November 27, 1984

FACILITY: Watts Bar Nuclear Plant  
Units 1 and 2

SUBJECT: SUMMARY OF MEETING TO DISCUSS TVA'S APPEAL REGARDING FIRE  
PROTECTION FOR THE WATTS BAR NUCLEAR PLANT, UNITS 1 AND 2

**TVA HAS PROPOSED TO APPLY MODIFICATIONS TO COMPENSATE FOR INTERVENING COMBUSTIBLES TO A SINGLE AREA 20 FEET IN WIDTH BETWEEN REDUNDANT TRAINS OF SAFE SHUTDOWN EQUIPMENT AND RELATED CABLES.**

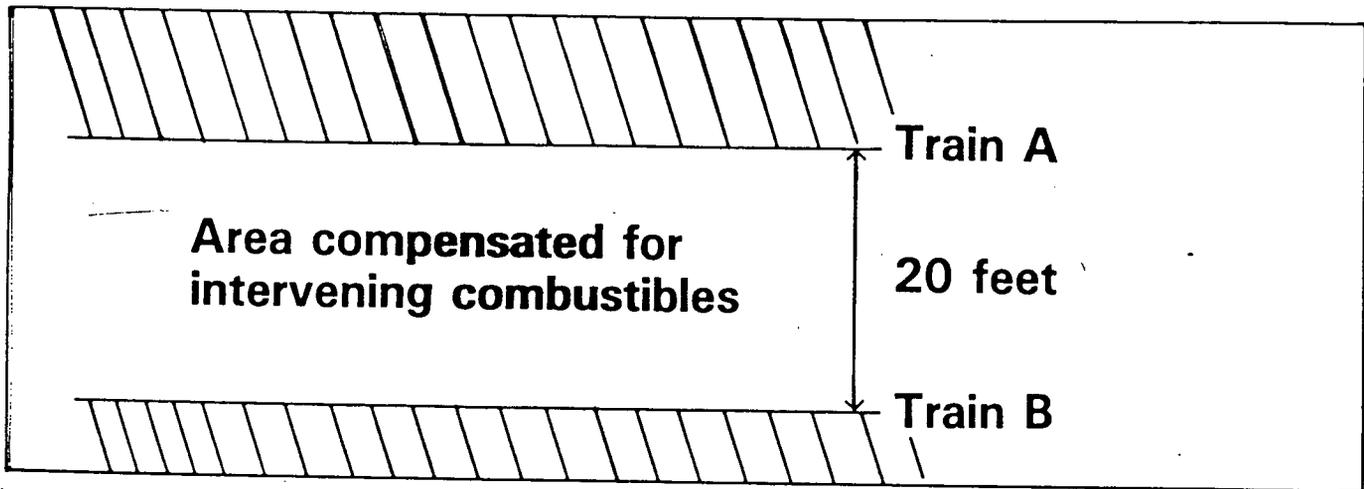
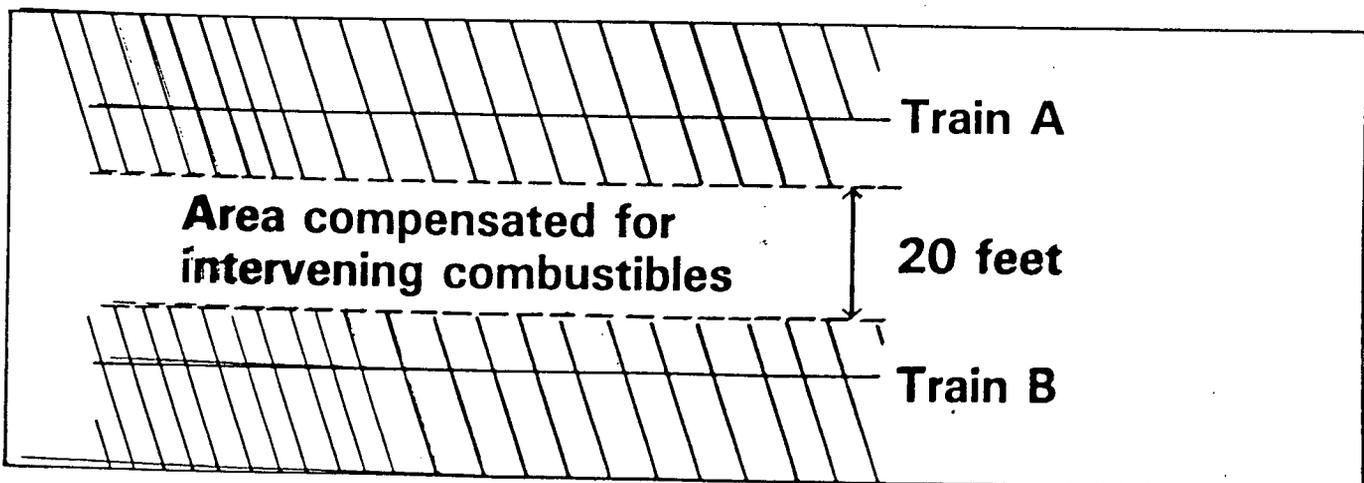
In addition, the staff pointed out that the 20 foot separation requirement is based on the conditions that there are no intervening combustibles within that 20 feet and that there is an adequate sprinkler system. The staff's position is that the 20 foot strip with intervening combustibles and a sprinkler system as proposed by TVA, is not equivalent to a 20 foot strip with a sprinkler system and without intervening combustibles. The staff stated that TVA seemed to be emphasizing the issue concerning intervening combustibles while the staff has determined that, if the issue of the inadequate sprinkler system throughout the facility is resolved, then the issue of intervening combustibles will be resolved. The staff stated that the proposed implementation of TVA's criteria will not ensure that a fire at the floor level will be extinguished and therefore, the consequences of a fire will not be mitigated. TVA stated that the cumulative obstructions found throughout the Watts Bar plant can still permit heat to actuate the sprinkler system and control the fire and the heat plume created by the event. The staff stated that the nature of the obstructions are such that the heat may be prevented from reaching the sprinkler system to ensure adequate mitigation of the fire.

- (1) A minimum of 30 feet of separation with intervening combustibles and a sprinkler system which meets the stricter criteria would provide equivalency to 20 feet of separation with an adequate sprinkler system and no intervening combustibles.

- (2) The stricter criteria do not need to be applied to all fire areas that contain safety/shutdown-related systems (both cables and components). The stricter criteria must be applied to the 30 foot area discussed in paragraph (1) above.
